Access Compliance Report

Public Rights-of-Way

(Curb Ramps)

Intersection ID: 45521	Main Street: HEDGEROW PARK RD	Cross Street: MEADOW_BOTTOM_RD	Location: W
ADA ID: 1A649C040767	Ramp Type: PerpDiag	Initial Pass/Fail: Fail	Overall Compliance: No
		Severity Score: 47.5

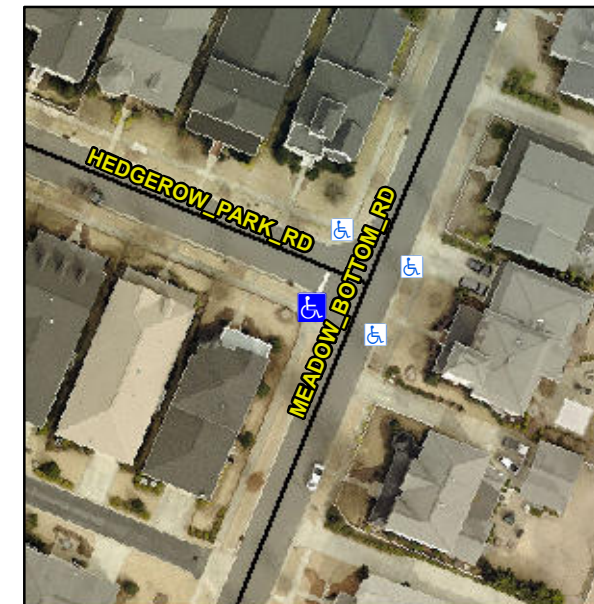
Not Found, R304.5.1, R304.2.2

Compliance	Description	Data	Compliance	Description	Data
N/A	Ramp Length (in)	73.0	No	Ramp Slope (%)	8.6
No	Ramp Width (in)	28.0	Yes	Ramp XSlope (%)	1.1
N/A	Flare Type LT	N/A	N/A	Flare Type RT	N/A
N/A	Flare Slope LT (%)	N/A	N/A	Flare Slope RT (%)	N/A
N/A	Flare Traversable LT?	N/A	N/A	Flare Traversable RT?	N/A
N/A	Landing Length (in)	N/A	N/A	DWS Provided?	N/A
N/A	Landing Width (in)	N/A	N/A	DWS Contrast?	N/A
N/A	Landing Slope (%)	N/A	N/A	DWS Length (in)	N/A
N/A	Landing X Slope (%)	N/A	N/A	DWS Full Width?	N/A
N/A	Landing Curb? (Y/N)	N/A	N/A	DWS Offset (in)	N/A
N/A	Shared Landing?	N/A			
N/A	Gutter Ponding?	N/A	N/A	Gutter Slope (%)	N/A
N/A	Gutter Lip Ht (in)	N/A	N/A	Gutter X Slope (%)	N/A
N/A	Painted X Walk1?	No	N/A	Painted X Walk2?	No
	X Walk 1 Direction	To SE		X Walk 2 Direction	To NE
N/A	X Walk 1 Width (in)	N/A	N/A	X Walk 2 Width (in)	N/A
	X Walk 1 Slope (%)	2.7		X Walk 2 Slope (%)	1.5
	X Walk 1 X Slope (%)	2.1		X Walk 2 X Slope (%)	2.1

Remove & Replace Curb Ramp With Two New Directional Ramps or Equivalent.
